**STATE OF HAWAII
DEPARTMENT OF TRANSPORTATION
AIRPORTS**

**ADDENDUM NO. 1
FOR
APRON LIGHT REPLACEMENT
AT
KAHULUI AIRPORT
KAHULUI, MAUI, HAWAII
AND
LANAI AIRPORT
LANAI CITY, LANAI, HAWAII
STATE PROJECT NO. AS1037-12R
AIP PROJECT NO. 3-15-0006-064-2025**

April 2, 2026

ELECTRICAL DEMOLITION PLAN 1

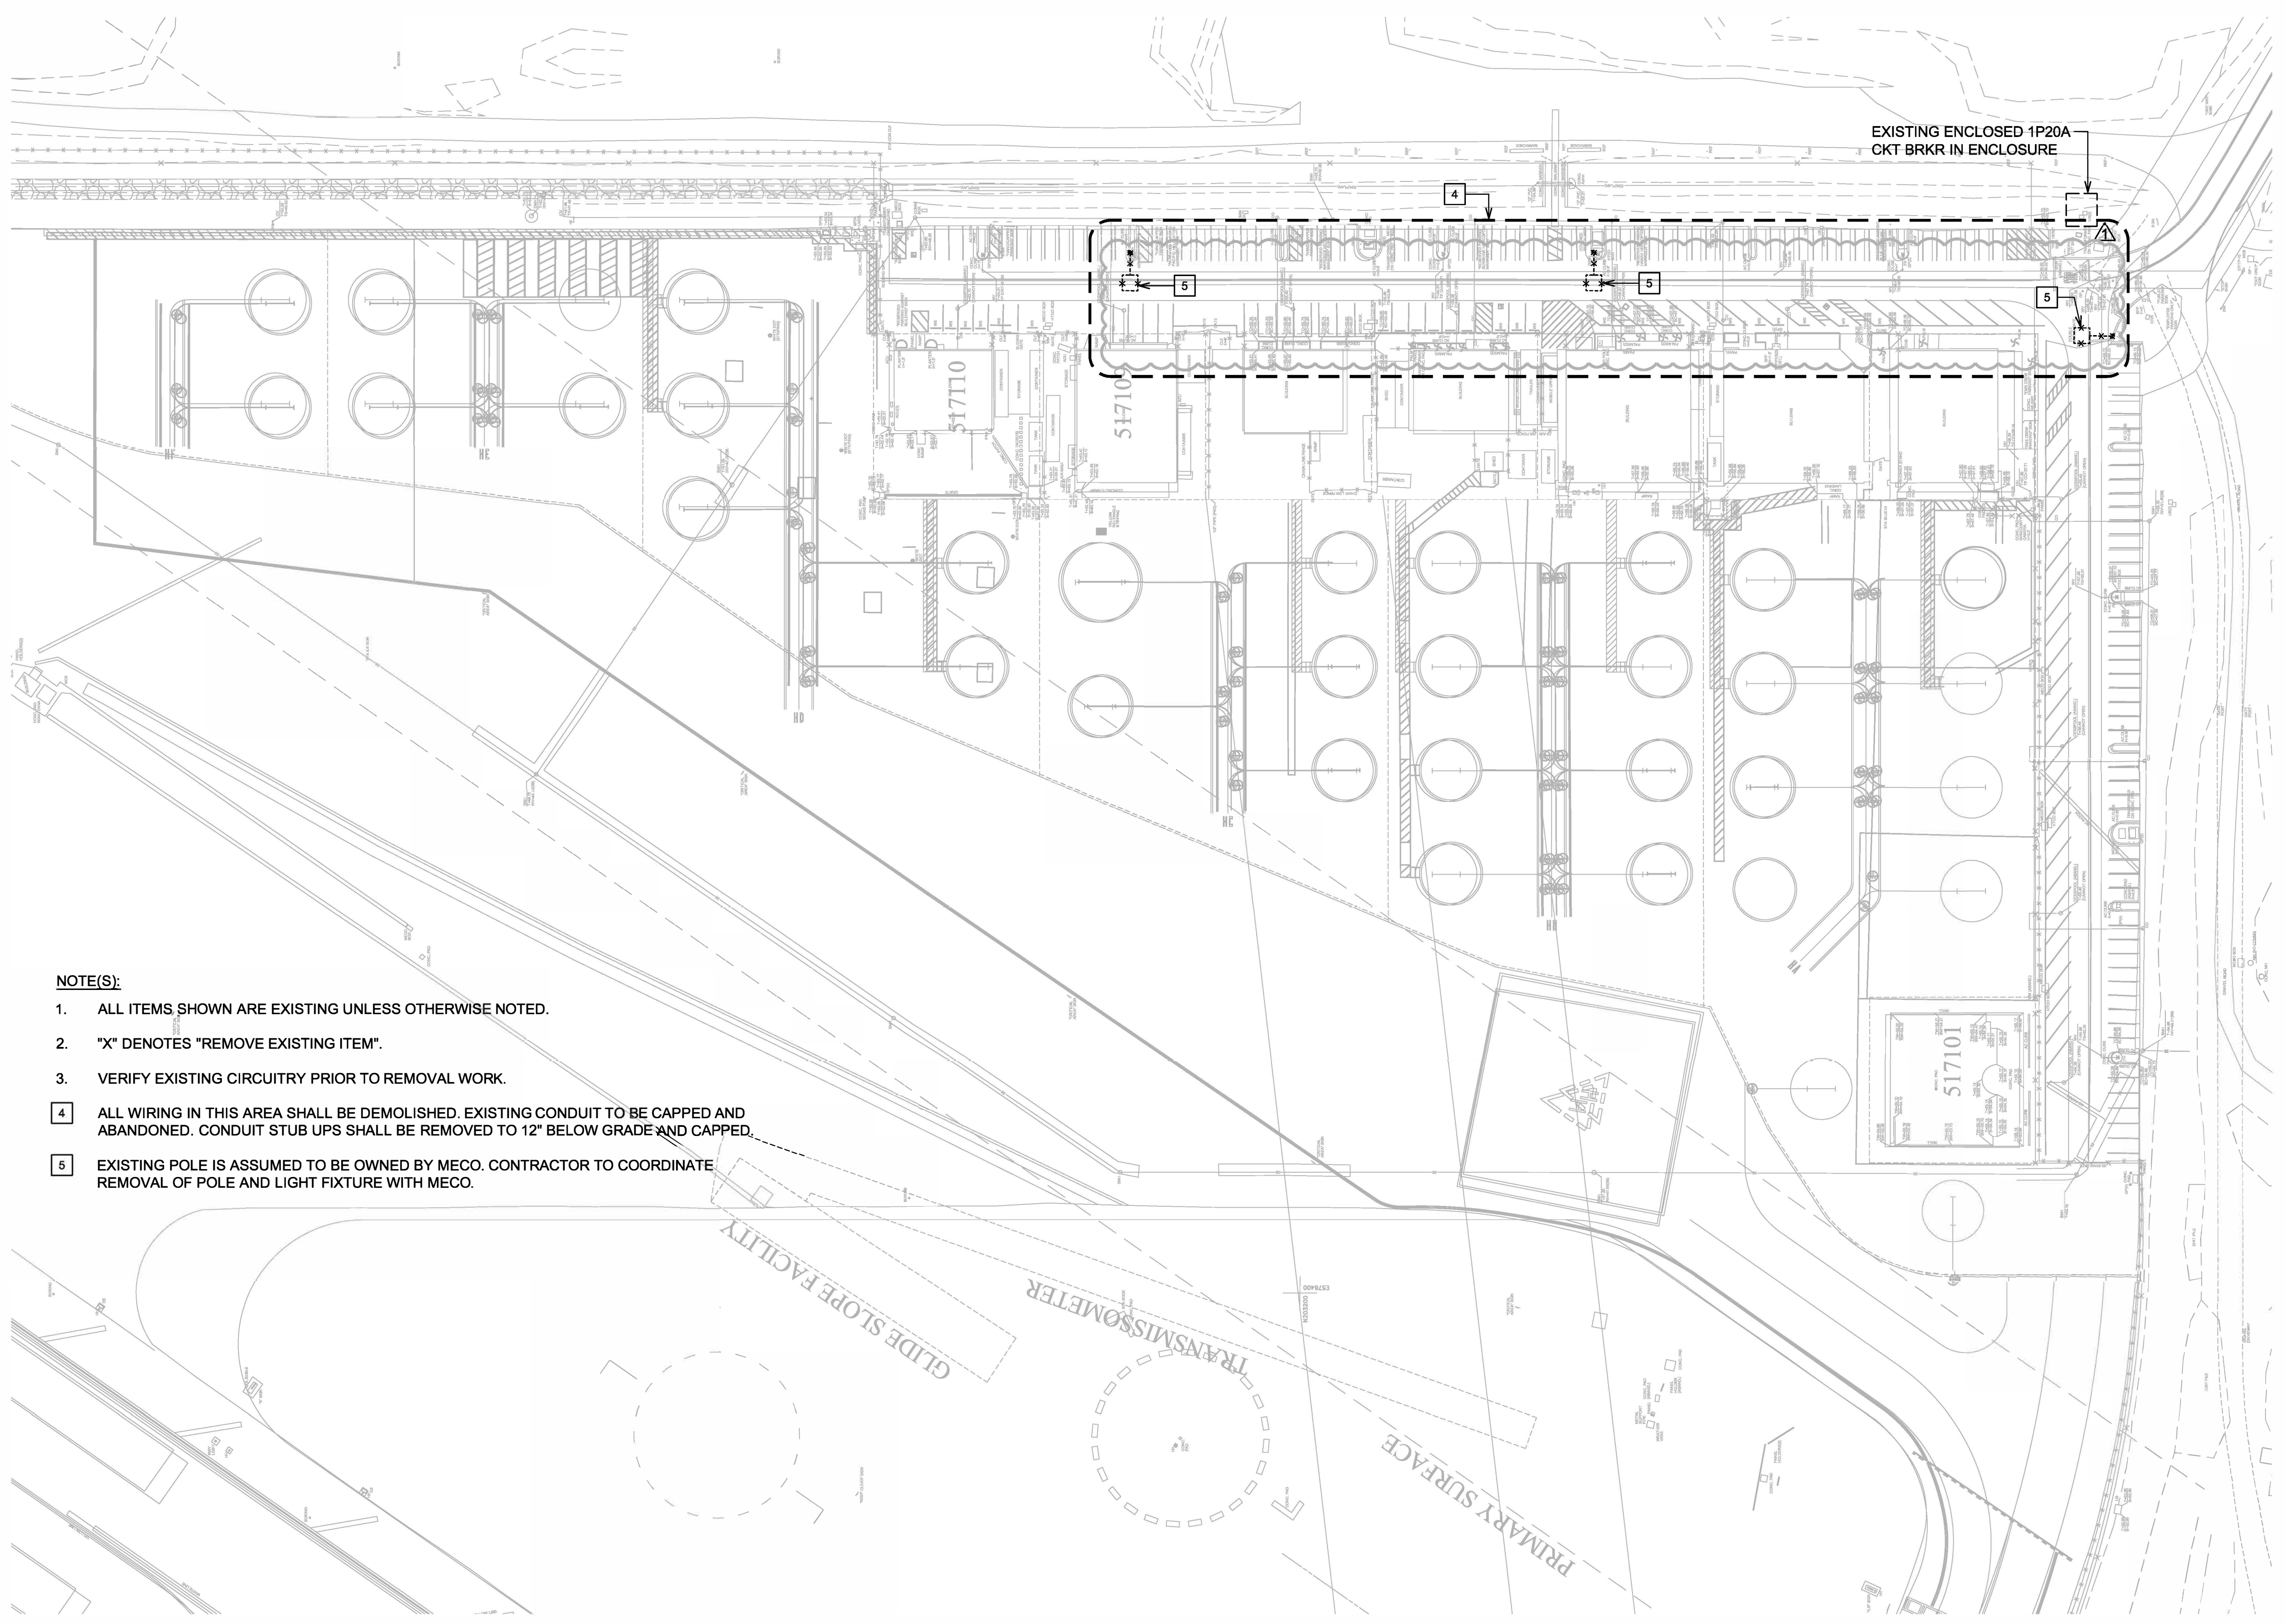
1. Delete **PLANS SHEET NO. E101, ELECTRICAL DEMOLITION PLAN 1** and replace it with attached **PLANS SHEET NO. ADD. 1 E101, ELECTRICAL DEMOLITION PLAN 1**.

**ELECTRICAL
DEMOLITION PLAN 4**

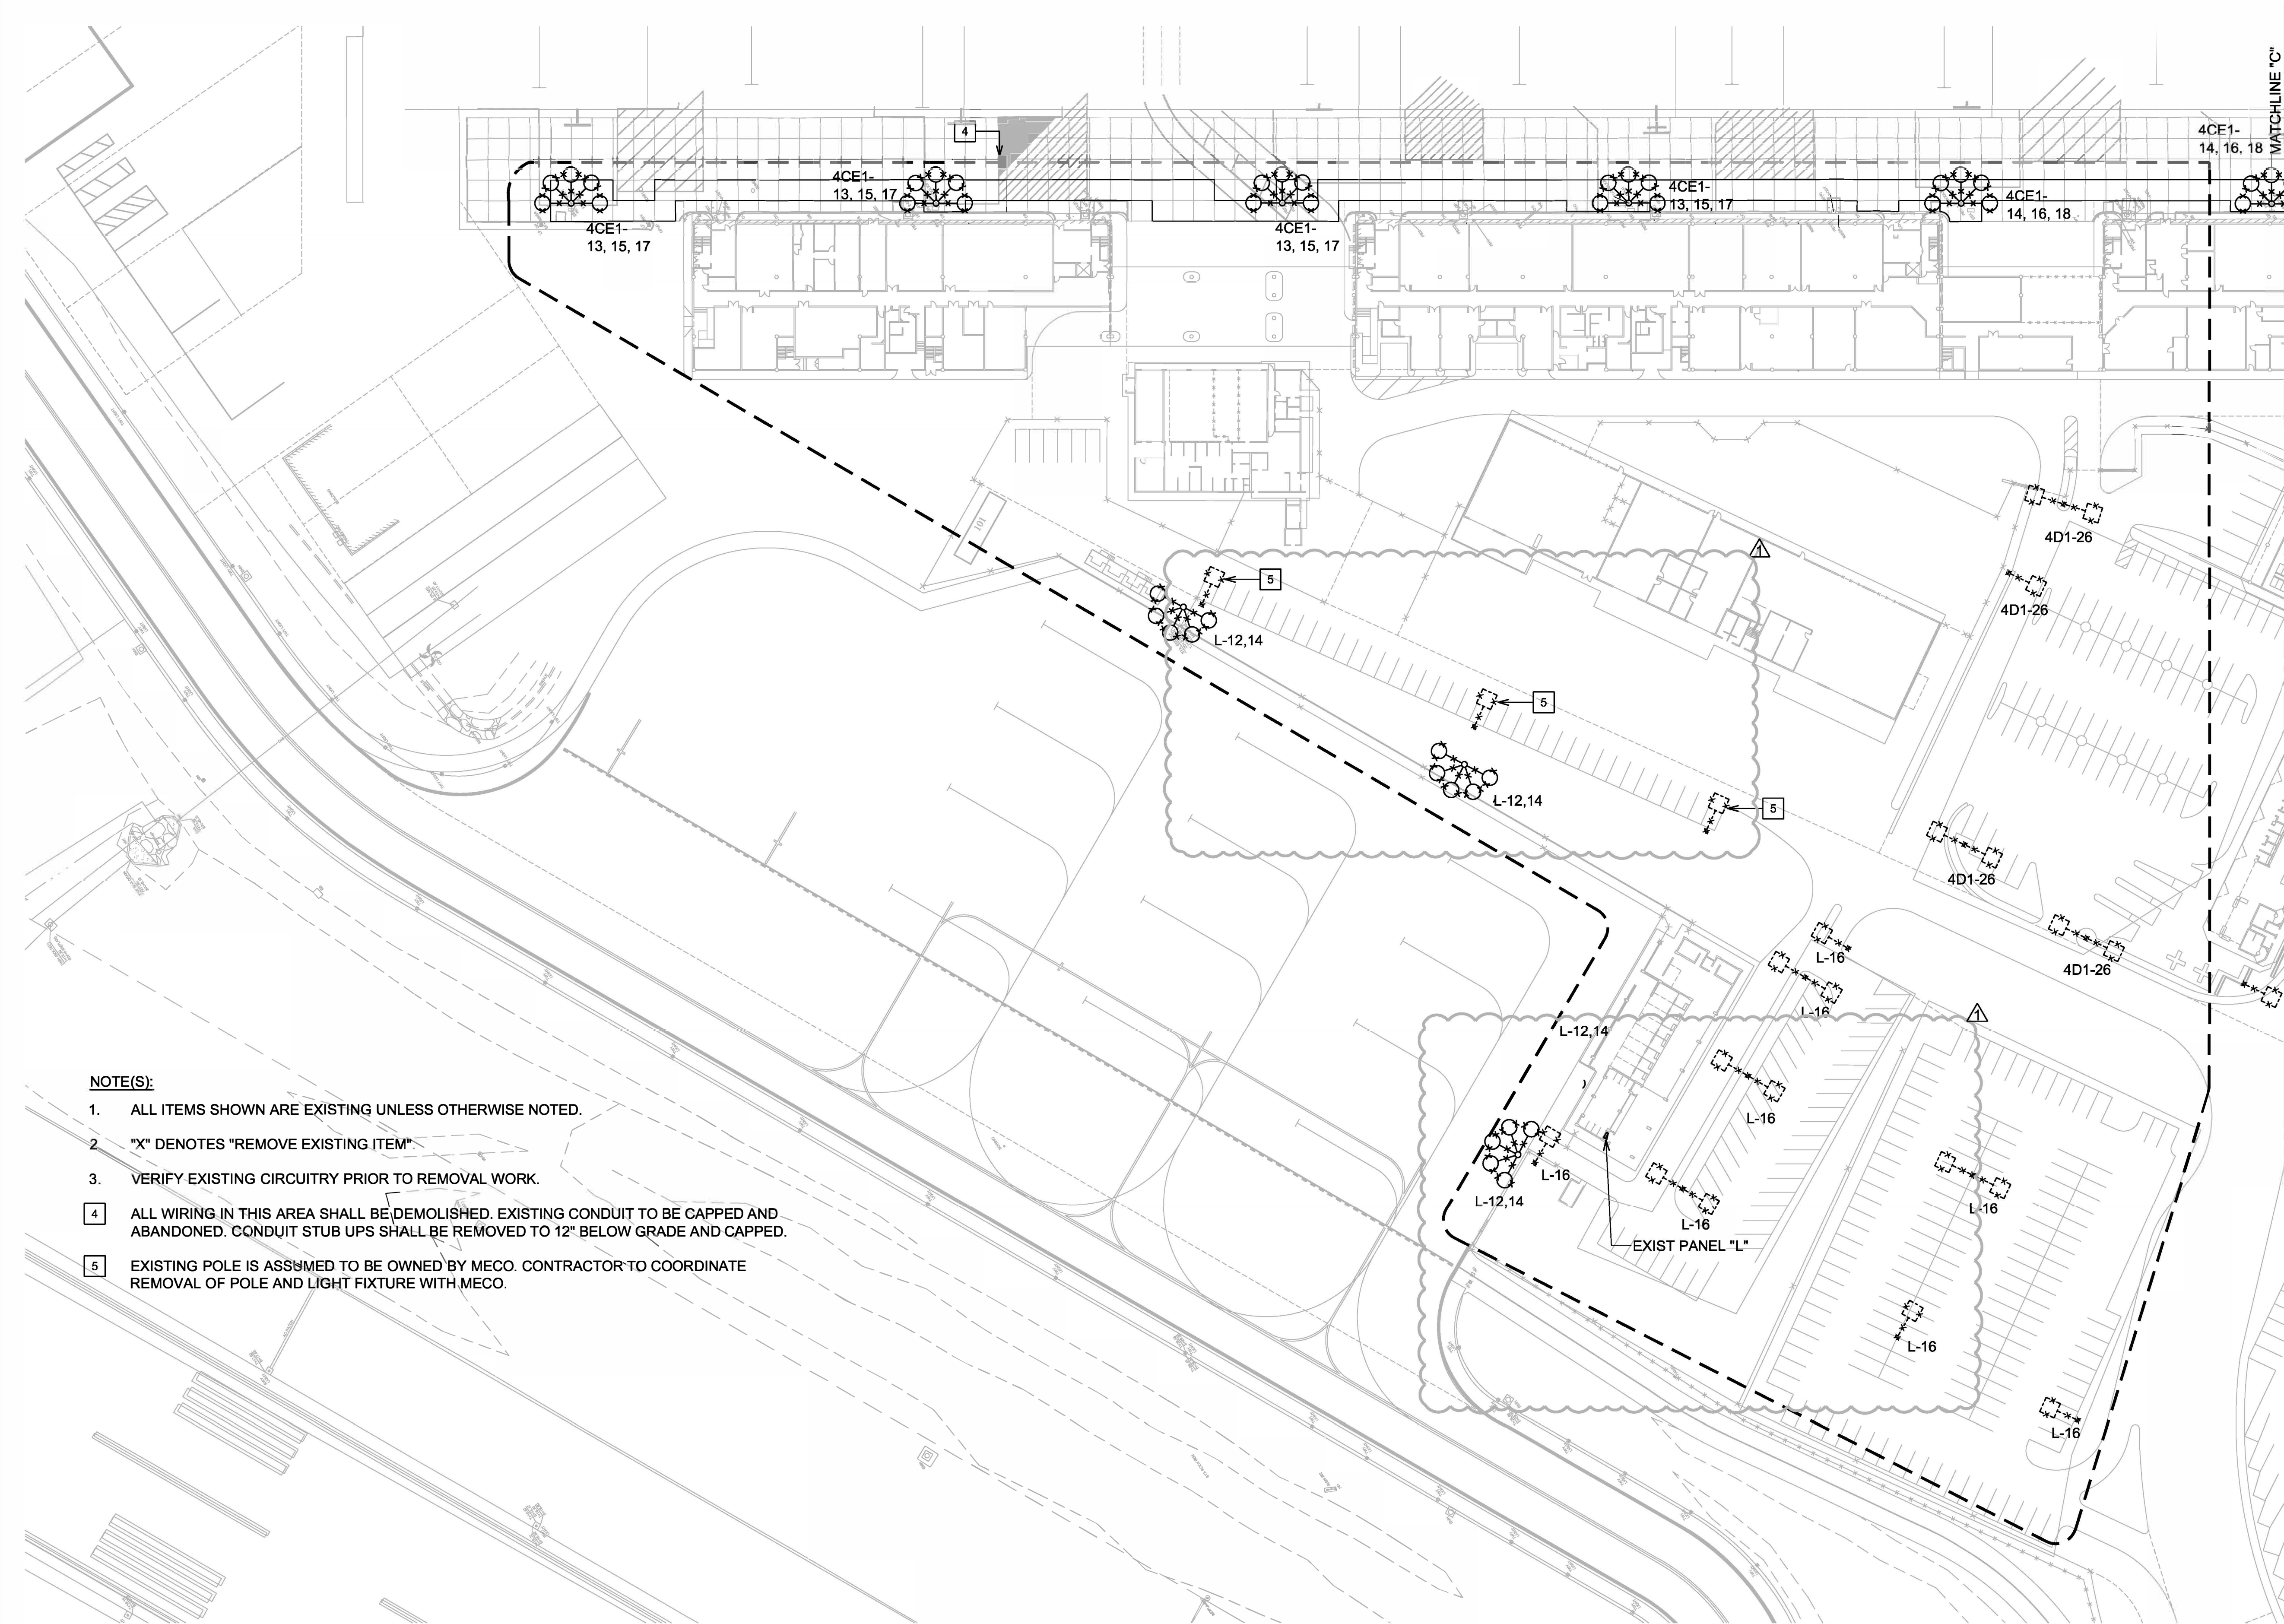
2. Delete **PLANS SHEET NO. E104, ELECTRICAL DEMOLITION PLAN 4** and replace it with attached **PLANS SHEET NO. ADD. 1 E104, ELECTRICAL DEMOLITION PLAN 4**.

**ELECTRICAL
DEMOLITION PLAN 5**

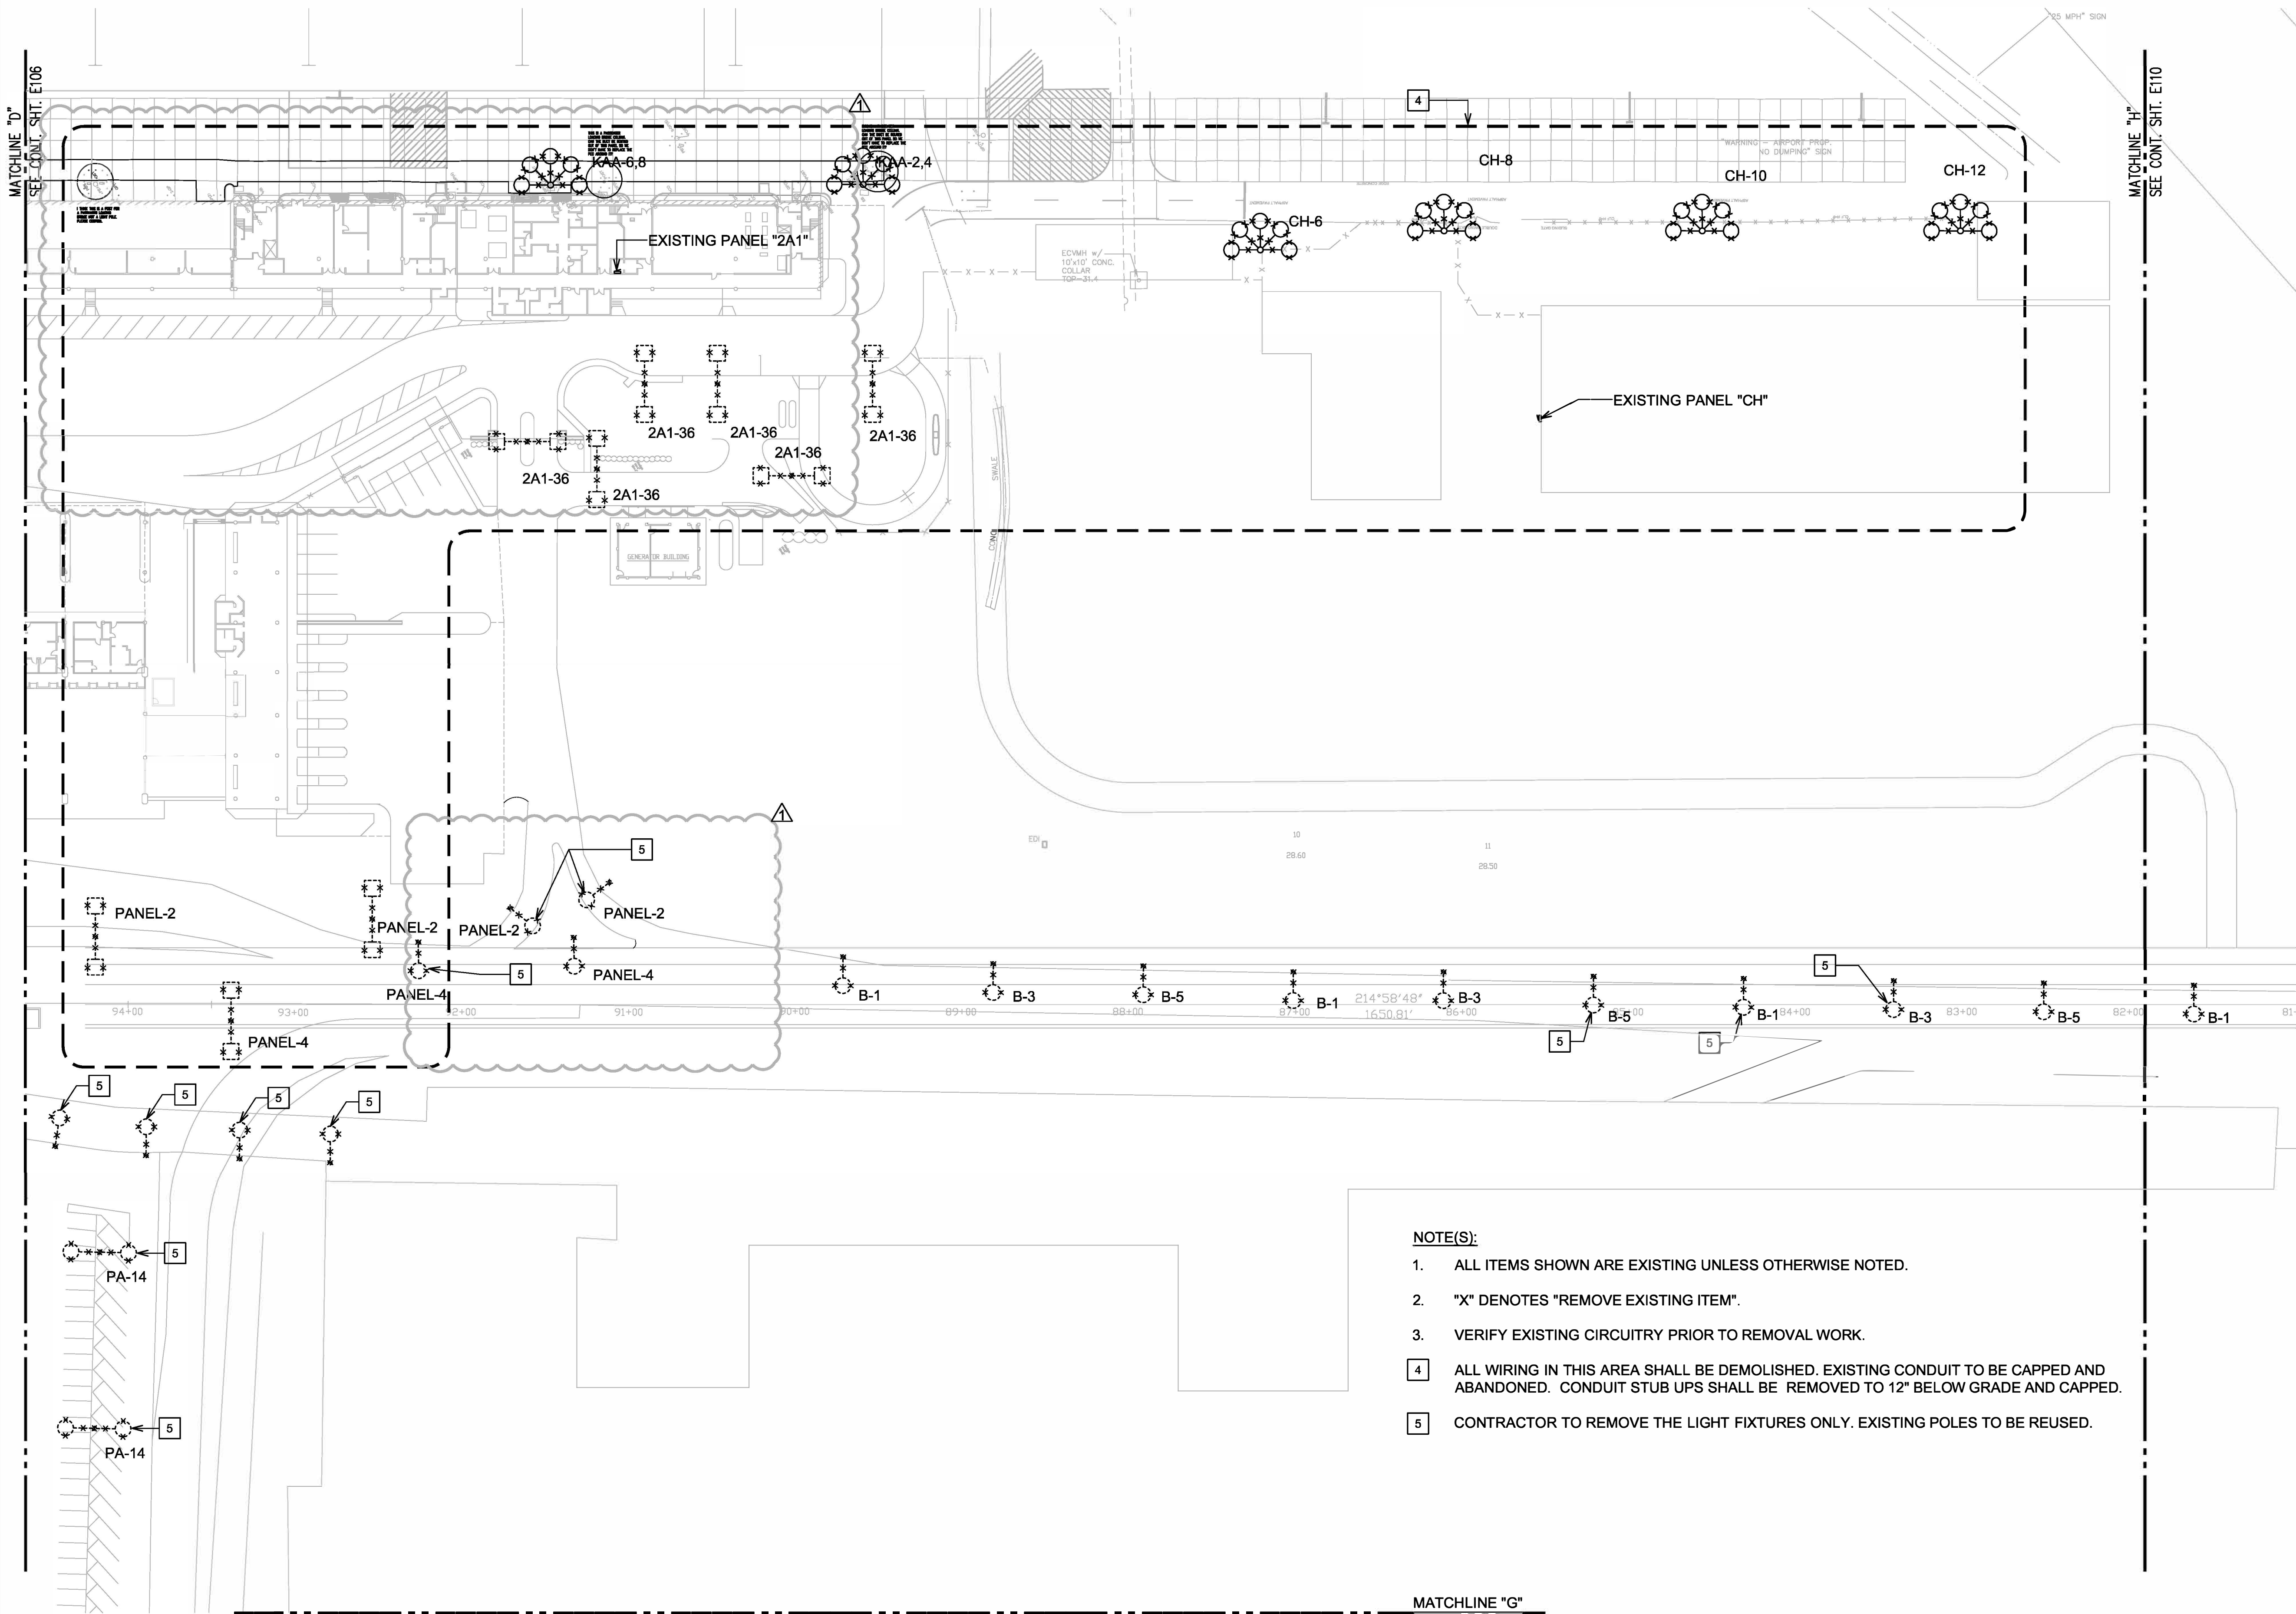
3. Delete **PLANS SHEET NO. E105, ELECTRICAL DEMOLITION PLAN 5** and replace it with attached **PLANS SHEET NO. ADD. 1 E105, ELECTRICAL DEMOLITION PLAN 5**.
